**CERTIFICATE OF APPROPRIATENESS**

**Property:** 1748 North Blvd, Lots 3 & 4, Block 5, Ormond Place Subdivision. The property is a vacant 21,000 square foot (170' x 150') interior lot.

**Proposal:** New Construction – Residence/Garage

**ATTACHMENT A**  
**CIVIC ASSOCIATION COMMENT**  
**BOULEVARD OAKS CIVIC ASSOCIATION**

**SOUTH ELEVATION – FRONT FACING NORTH BLVD**  
**PROPOSED**

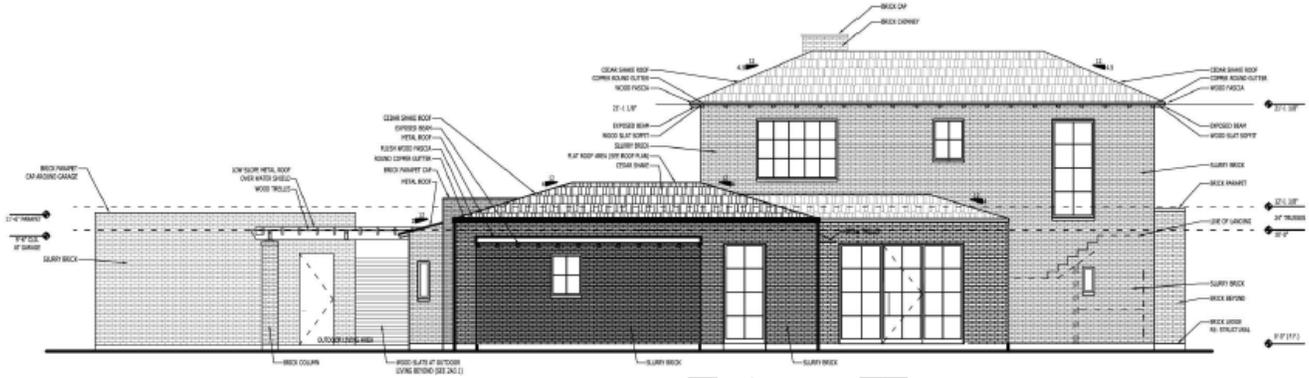
With respect to "width" considerations under Criterion #3, the Committee has concern that the six-foot brick wall extending from the west façade could potentially create the visual impression that the width of the structure itself extends all the way to the west property line, which would be out of scale, and out of proportion. The Committee understands the wall's objective of affording privacy for the enclosed garden area behind it, but the Committee requests that this "width" concern be considered and mitigated, for example with appropriate landscaping.

With respect to "height" considerations under Criterion #3, the heights above grade of the doors, windows, porch, eaves and roof of the proposed structure, as well as their proportions with each other, with width, and with other features, appear to be compatible with those of existing contributing structures in the context area and the Boulevard Oaks Historic District. However, the Application proposes a slab at grade, which will create a "foundation height," and a relationship between that foundation height and the other dimensions of the residence, that would not be consistent with any of the twelve existing contributing structures in the context area. In addition, as mentioned below, the HAHC's published "Defining Features" specifically list slab at grade foundations as "incompatible" for buildings in the Boulevard Oaks Historic District. The Committee understands that there may be economic or other considerations that could lead the applicant to propose a slab at grade foundation. Nevertheless, the Committee respectfully requests that the applicant consider a raised pier and beam or other above-grade foundation height that would make the height of the foundation and entry porch, and the scale and proportions of those elements in relation to the other exterior elements of the residence, consistent and "compatible" with those of the twelve existing contributing structures in the context area as well as virtually those of virtually all of the other contributing structures in the Boulevard Oaks Historic District.

**PROPOSED**

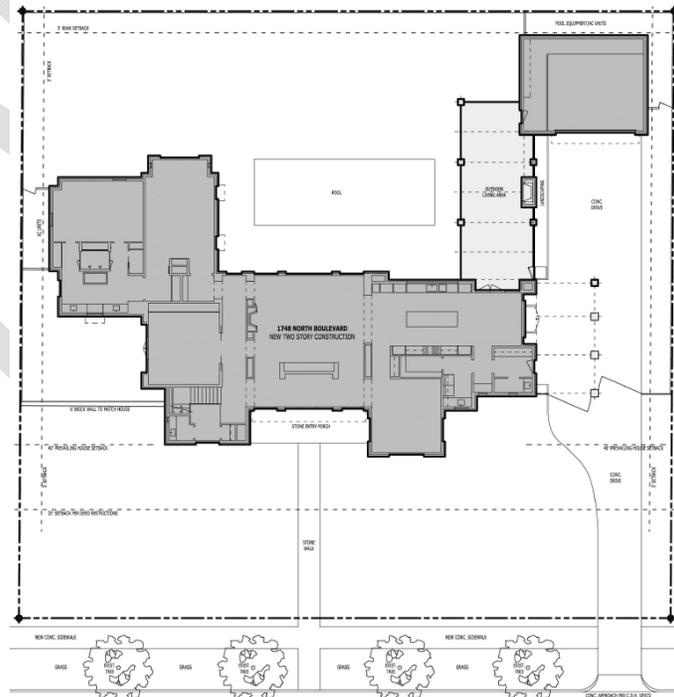
- The proposed building setbacks are similar to that of historic buildings located within the context area. The majority of the building falls behind the prevailing 40' setback and the one portion that extends over the prevailing line is at 37' – 6".*

The new residence will, essentially and almost entirely, conform to the 40-foot front setback prevailing along the esplanades within the Boulevard Oaks Historic District. The property is located within Ormond Place, where deed restrictions provide for a 25-foot setback. A 25-foot setback would be appropriate for new construction on other streets within Ormond Place, which have smaller lots, do not have esplanades, and are not included within the Boulevard Oaks Historic District. However, the Committee wishes to stress to the HAHC its strongly held and unanimous view that a setback of only 25 feet would be jarringly incompatible with the prevailing setbacks of homes fronting on the esplanades of North Boulevard and South Boulevard within the Boulevard Oaks Historic District.

ROOF PLAN  
PROPOSED

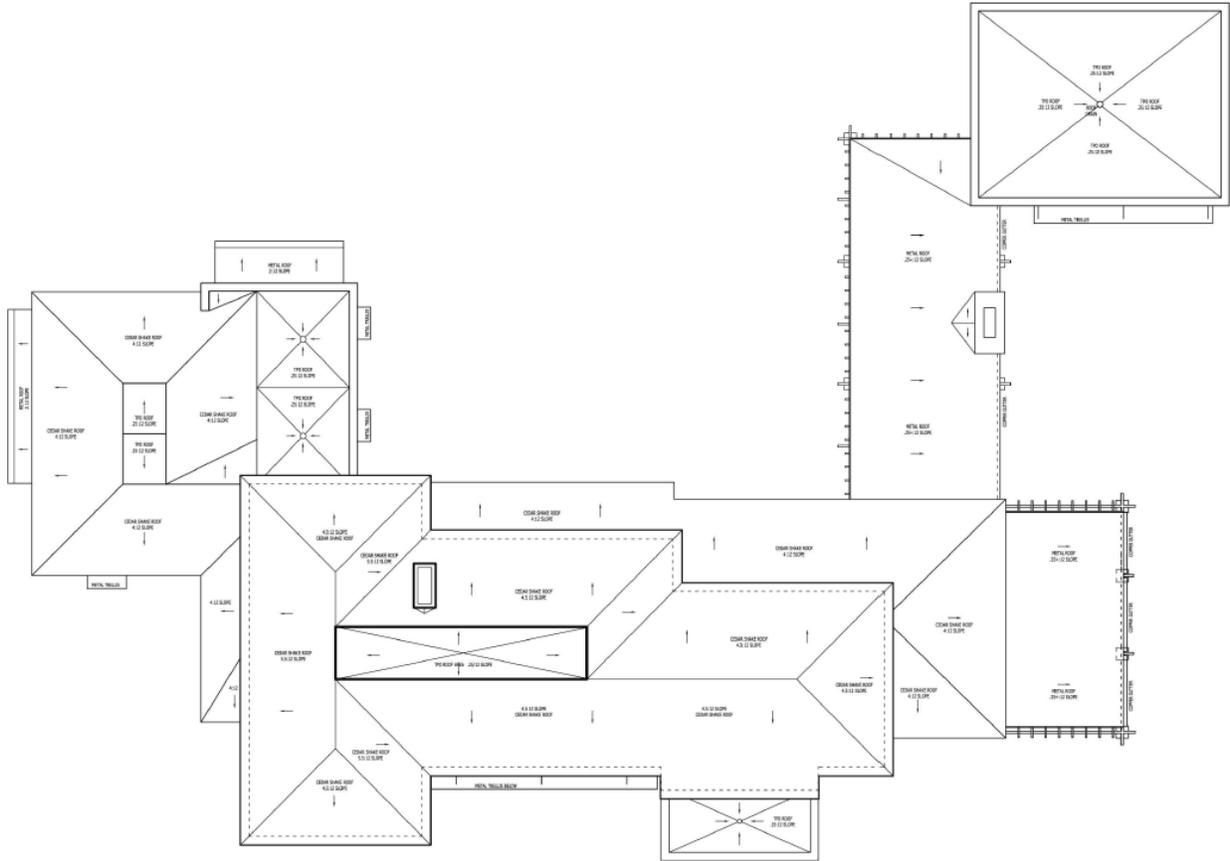
With respect to "roof shape and roof pitch" considerations under Criterion #3, the Application specifies 14 pitched roofs, seven with 4.0:12 slope, five with 4.5:12 slope, and two with 5.5:12 slope. These roofs have noticeably lesser slopes than the pitched roofs of the 12 contributing structures in the context area. The Committee has concern that the lower roof slopes proposed in the Application may produce roof shapes, and proportions in relation to other elements, that would not, as required, "be compatible with the typical scale and proportions of existing contributing structures in the context area." While the Committee does not desire to intrude upon the aesthetic objectives of the design, nor to cause the structure to have an inappropriately massive appearance, the Committee respectfully requests that the HAHC and the applicant consider whether the two-story portion of residence, and its appearance in context, might benefit from some increase in the slopes of the pitched roofs.

The Committee also has no objection to the low (0.25:12) slope roofs proposed in the Application because they appear only in contexts that are consistent and "compatible" with the contributing structures in the context area. Likewise, the Committee does not object to the synthetic grass proposed for these roofs based on the Application's specifying that such synthetic grass will not be visible from the street. With respect to the slopes and shapes of the proposed pitched roofs, please see the comments above.

WINDOW / DOOR SCHEDULE

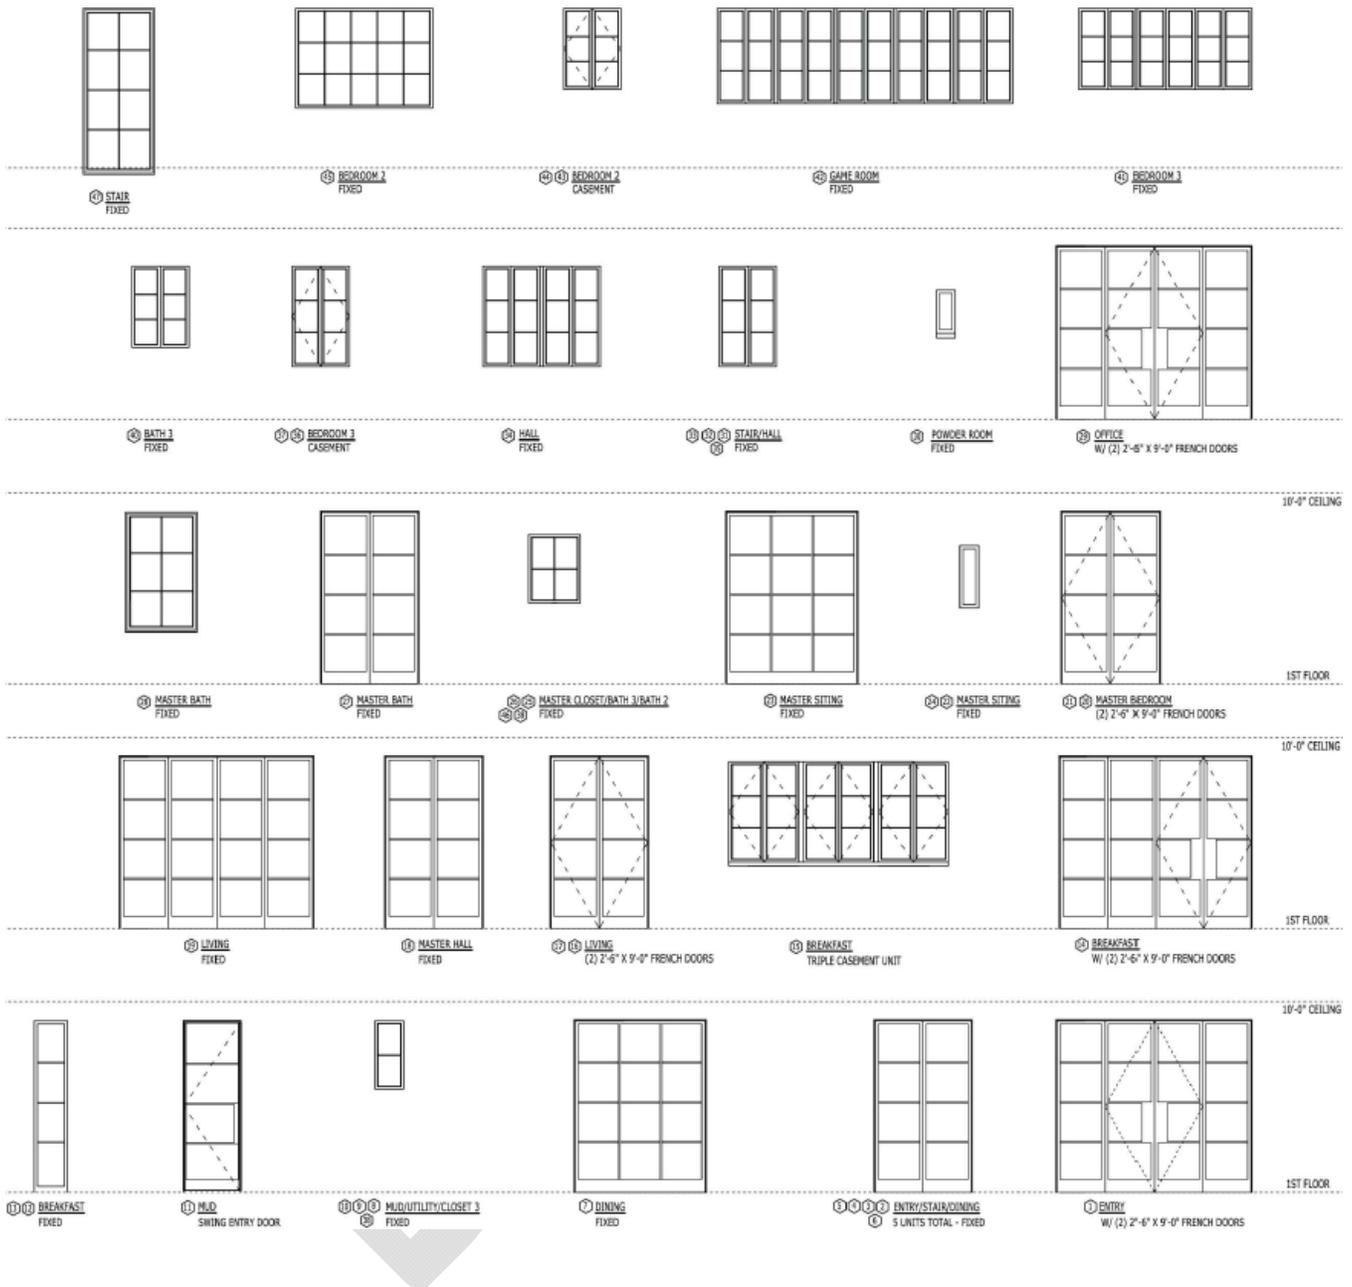
- Front Door. The Application states the "entry will be a custom fabricated architectural bronze unit, containing a single swing door with sidelights and transom." However, the plans in the Application do not appear to indicate any transoms, at the entry or elsewhere. The Committee notes that transoms are designated by the HAHC guidelines as "incompatible" for Boulevard Oaks Historic District.

- Windows. The Application initially states “The house will contain a combination of custom metal and wood fabricated windows (painted a light, off white color). The windows will have muntin/mullion divisions typical of a more traditional window/door with typical traditional detailing. Exterior single swing doors and French doors will also be custom fabricated metal frames with steel muntins (painted). The windows will be a mix of fixed and casement style outswings.” The “Window Notes” on the last page of the Application state “5. All windows to be painted light gray. 6 Glazing to be individual panes set within muntin frames; (2) 1/4” panels with low E film between.”

The “Defining Features” for Boulevard Oaks Historic District label as “compatible” windows that are wood or wood clad, and if they are double-hung, single-hung or casement. Conversely, the “Defining Features” label as “incompatible” windows that are aluminum or large plate glass. The “Defining Features” do not directly address windows, muntins, and mullions that are painted metal, nor do they appear to address fixed windows with muntins.

In assessing the windows described in the Application, the Committee has relied upon the applicant’s undertakings that the windows will be painted a light, off white color, will have muntin/mullion divisions typical of a more traditional window/door with typical traditional detailing, and will have individual panes set within muntin frames. From those statements in the Application, it is the Committee’s understanding that the windows will appear from the street to be a light, off-white color and compatible with the existing wood or wood clad divided light windows of the contributing structures in the context area. The Committee has also considered the size and proportions of these painted metal windows in the context of the architectural design of this particular proposed residence. Based on the foregoing, the Committee does not object to the proposed windows for the new residence at 1748 North Boulevard.
